1968 Corvette: Service Bulletin: Heat Damage to Engine Wiring Harness at Starter Solenoid

Model and Year: 1968 Corvette with 396 or 427 Cubic Inch Engine

Bulletin No: 68-T-66

Date: October 30, 1968

Figure 1

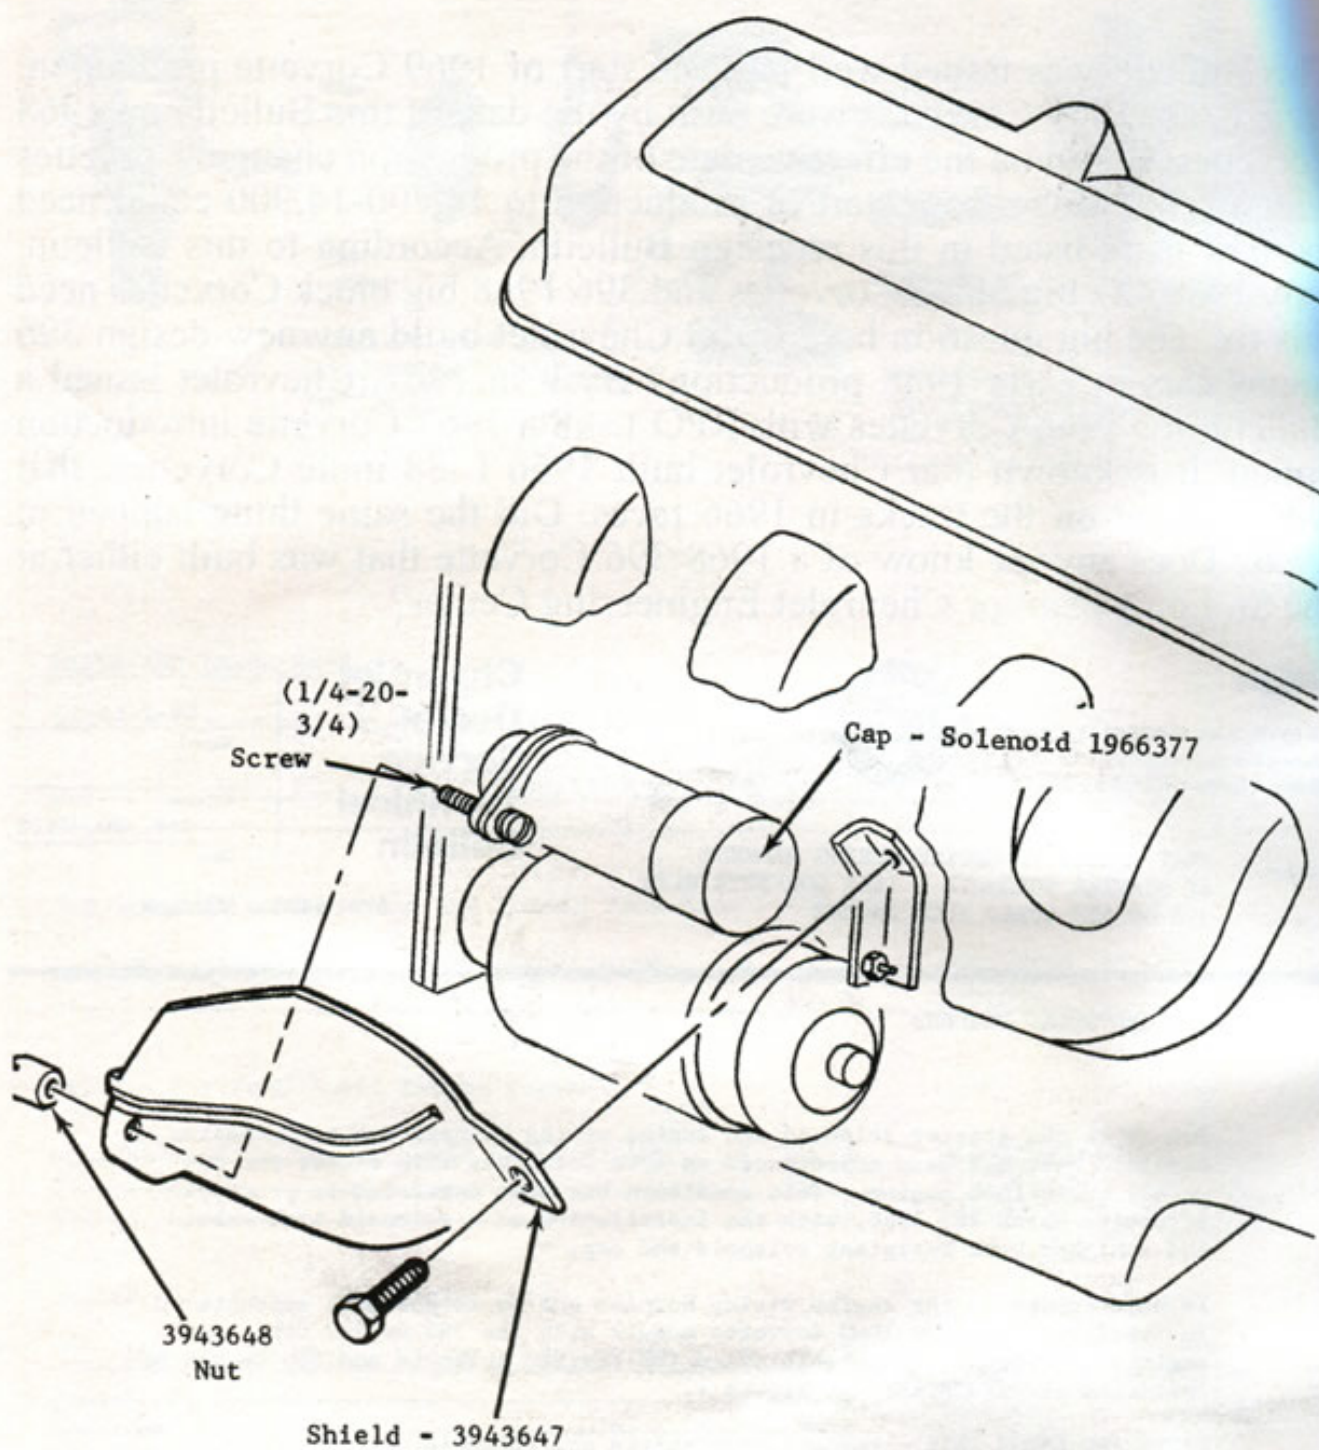
Damage to the starter solenoid and engine wiring harness due to excessive manifold heat has been experienced on 1968 Corvettes with either the 396 or 427 cubic inch engine. This condition has been corrected in production effective March 28, 1968, with the installation of a solenoid heat shield and a higher heat resistant solenoid end cap.

If heat damage to the engine wiring harness and/or solenoid is encountered in the field on early 1968 Corvette models with the 396 or 427 cubic inch engine, the solenoid heat shield and the revised solenoid end cap should be installed as illustrated in figure 1.

QUA.	PART NO.	PART DESCRIPTION
1.	1	3943647	Shield
2.	1	1966377	Solenoid Cap
3.	1	3943648	Special Nut
